# UNITED STATES PATENT AND TRADEMARK OFFICE

APPLICATION NO.	FILING DATE	FIRST NAMED INVENTOR	ATTORNEY DOCKET NO.	CONFIRMATION NO.
10/627,758	07/28/2003	Didier Martin	033818-007	4423

**Office Action Summary**

NEW SHEET  
Appln. Filing Date: July 28, 2003  
Title: TREAD WHICH REDUCES RUNNING NOISE  
Inventor(s): Didier Martin et al.  
Appln. No.: 10/627,758

FIG. 5

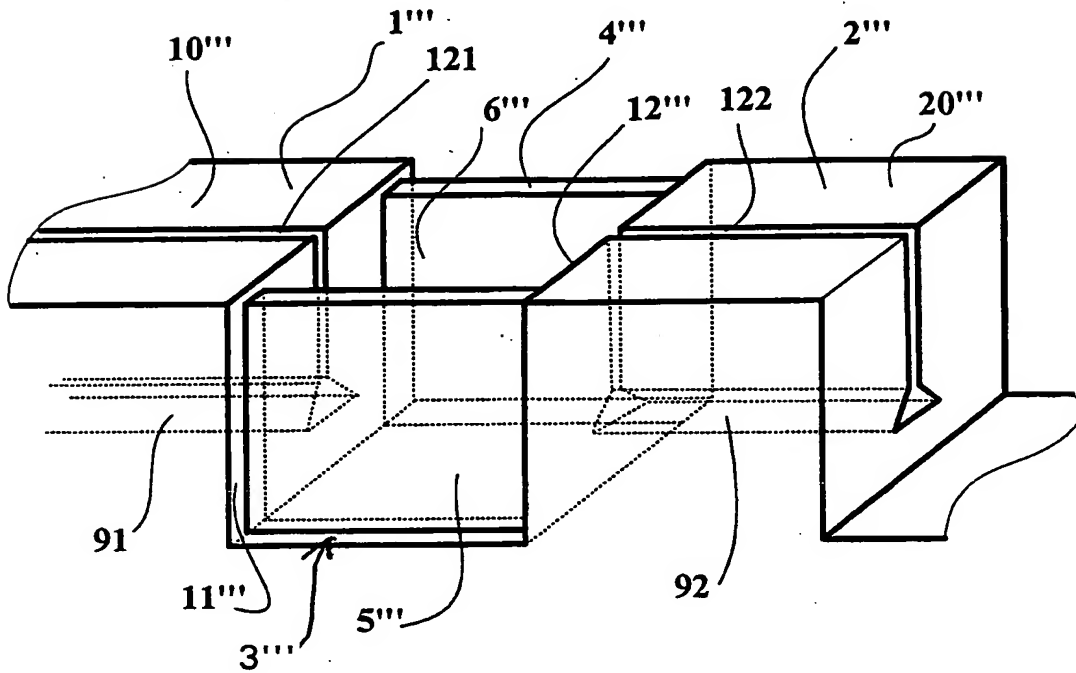
- 1) The proposed drawing correction for figure 5 filed 7-21-05 has not been approved by the examiner and accordingly has not been entered since the specification fails to describe 3".
- 2) The proposed drawing correction for figure 6 filed 7-21-05 has not been approved by the examiner and accordingly has not been entered. Reference numeral 51" in new figure 6 is not described in the specification. Also, see next paragraph in this office action.
- 3) The amendment filed 7-21-05 is objected to under 35 U.S.C. 132(a) because it introduces new matter into the disclosure. 35 U.S.C. 132(a) states that no amendment shall introduce new matter into the disclosure of the invention. The added material which is not supported by the original disclosure is as follows:

DO NOT ENTER  
Jm 10-3-05

FIG. 6

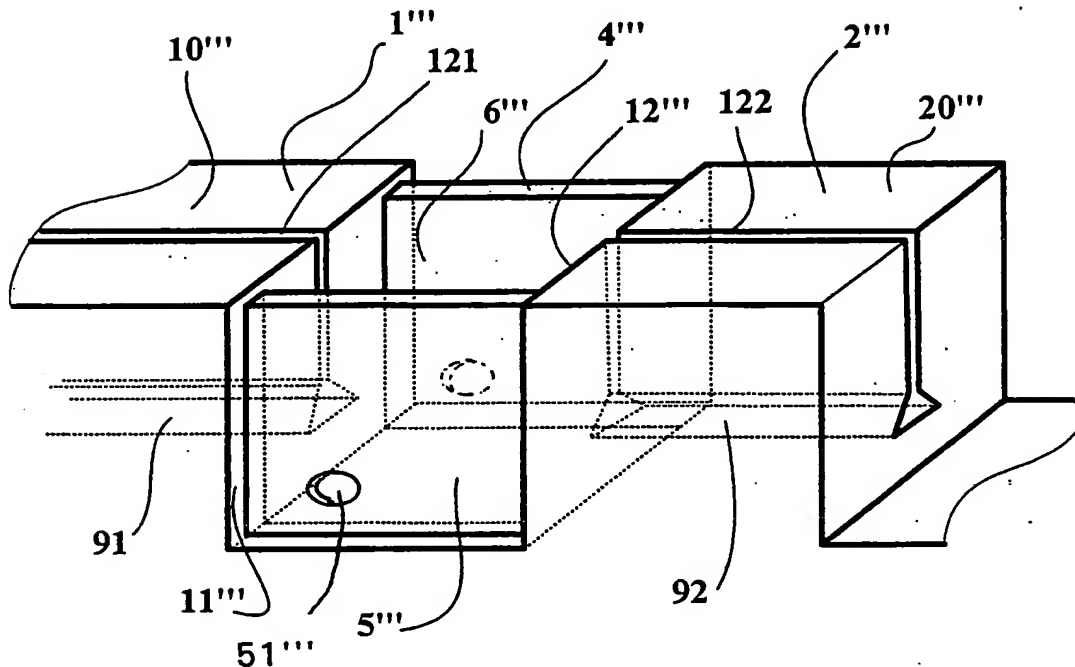
The new matter is new figure 6. Although the original disclosure describes combining a channel in the motifs and orifices in the connecting elements (page 8 lines 1-2), the original disclosure fails to reasonably convey the specific shape, number and location for the orifice as shown in new figure 6.

With respect to the drawings filed 7-21-05, new figure 6 has not been approved by the examiner and has not been entered. See MPEP 608.02(x), page 600-110, Rev. 2, May 2004 ("Where the corrected or changed drawings is not accepted, for example, because the submitted corrections or changes ... involve new mater ... applicant will be notified and informed of any corrected action in the next office action" and MPEP 608.04, page 600-112, Rev. 2, May 2004 ("a 'new matter' amendment of the drawing is ordinarily not entered ..."))

(2) The disclosure describes new figure 6, which as noted above, has not been entered.

DO NOT ENTER

Applicant is required to cancel the new matter in the reply to this Office Action.
